CURB RAMP PROGRAM

KATY ST
SIDEWALK SHEET D

SHEET 4 OF 5

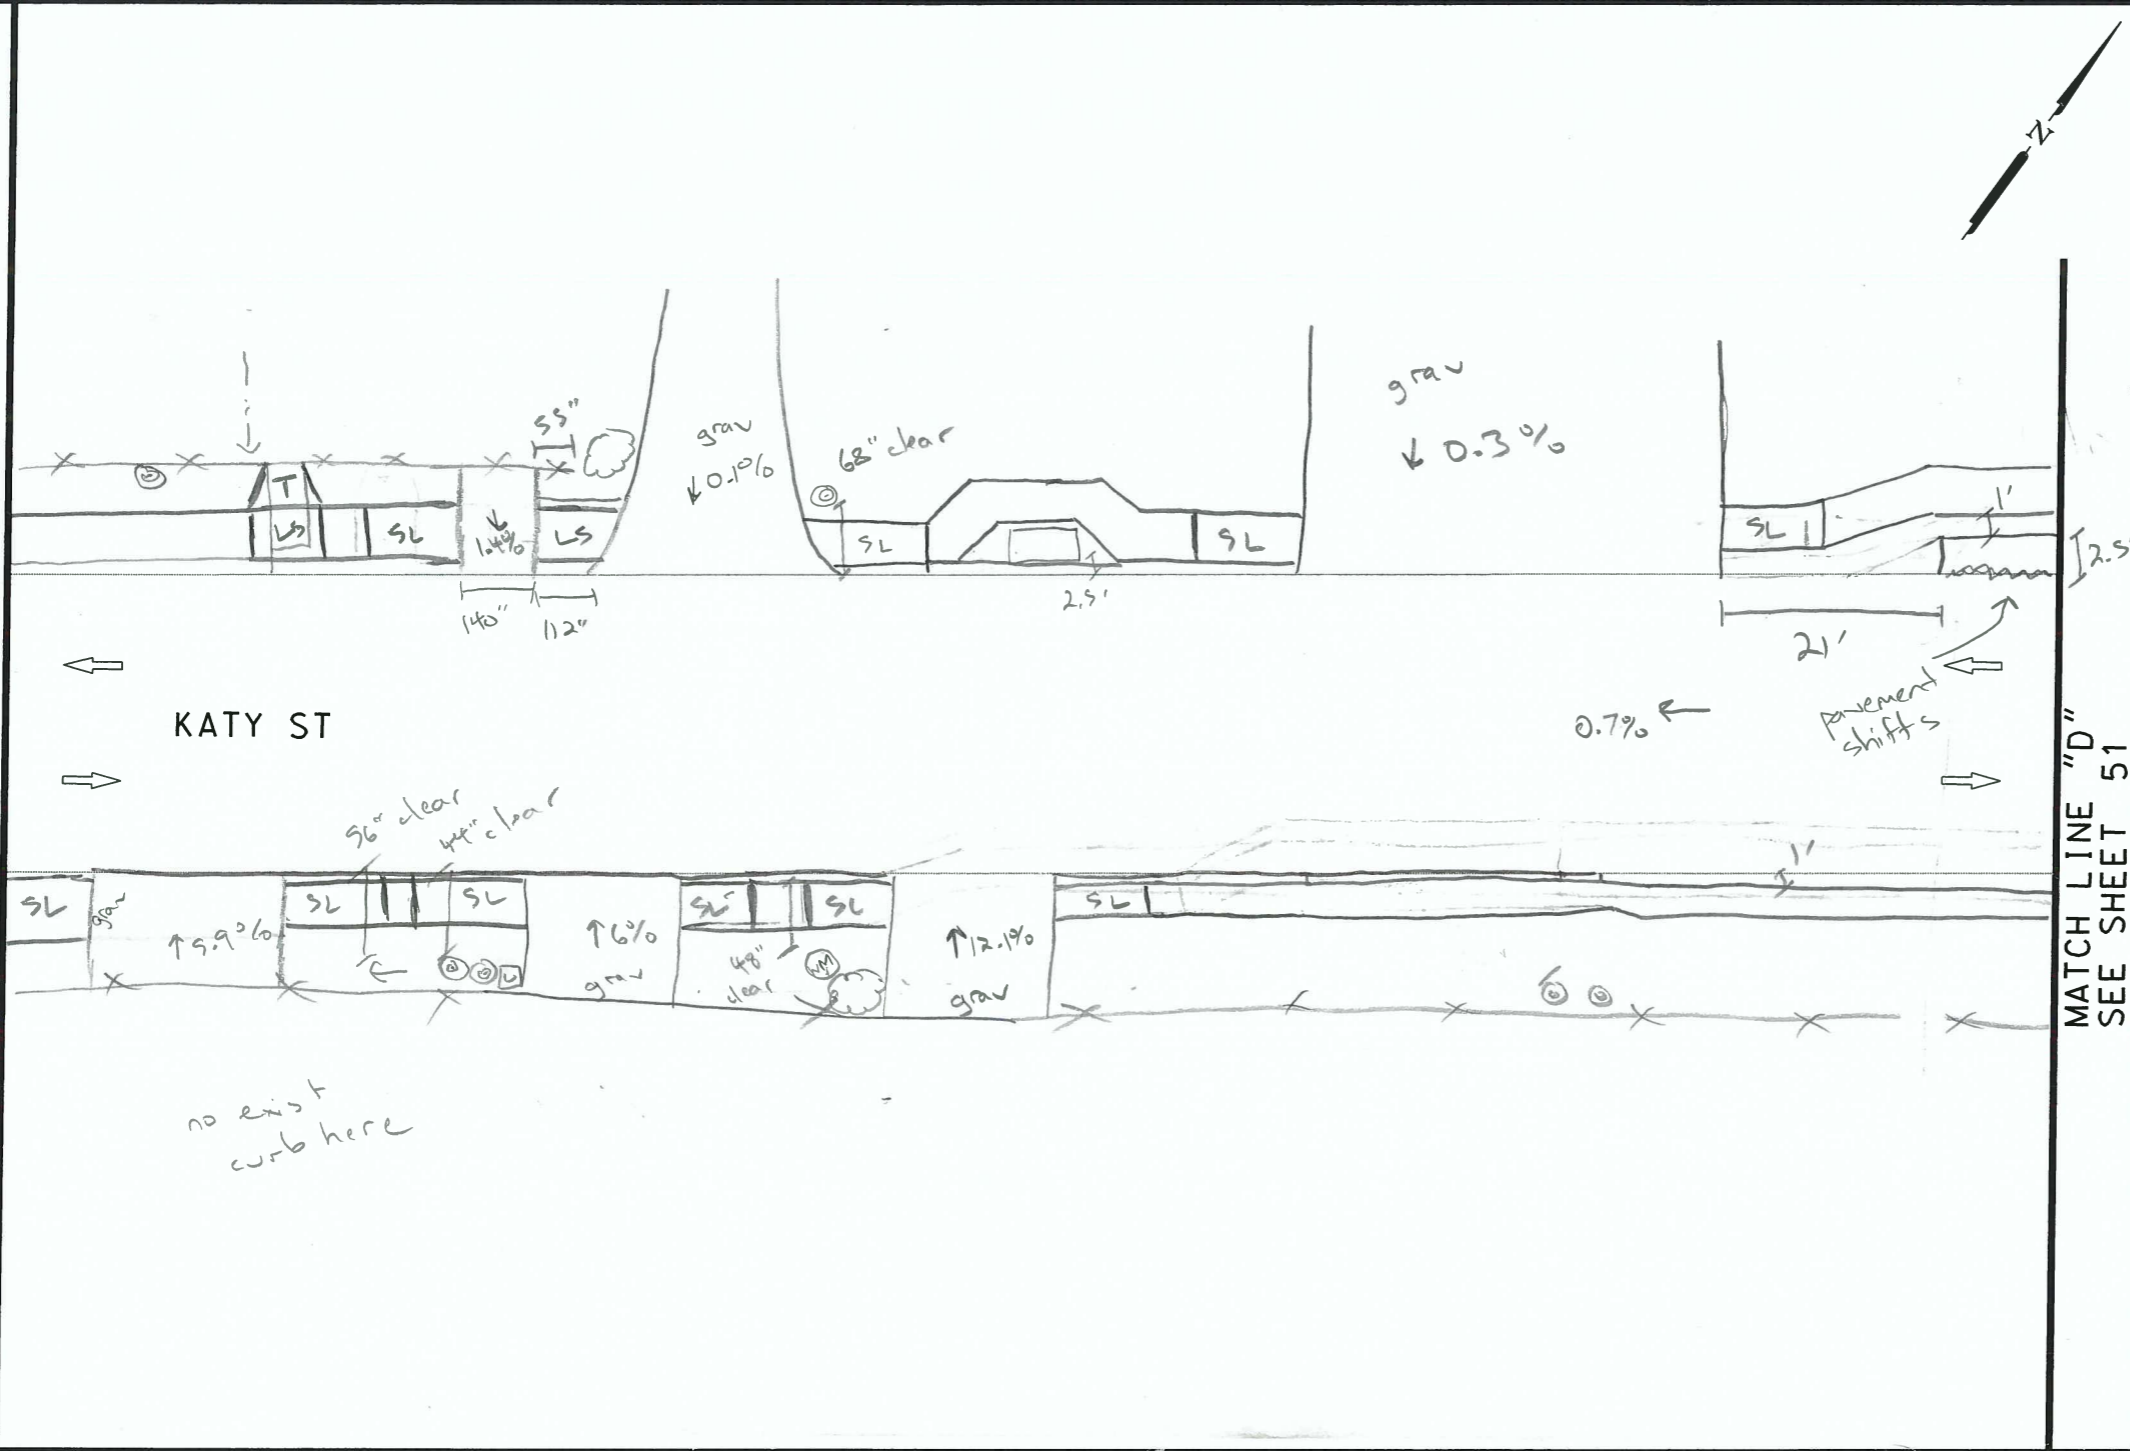
no exist curb here
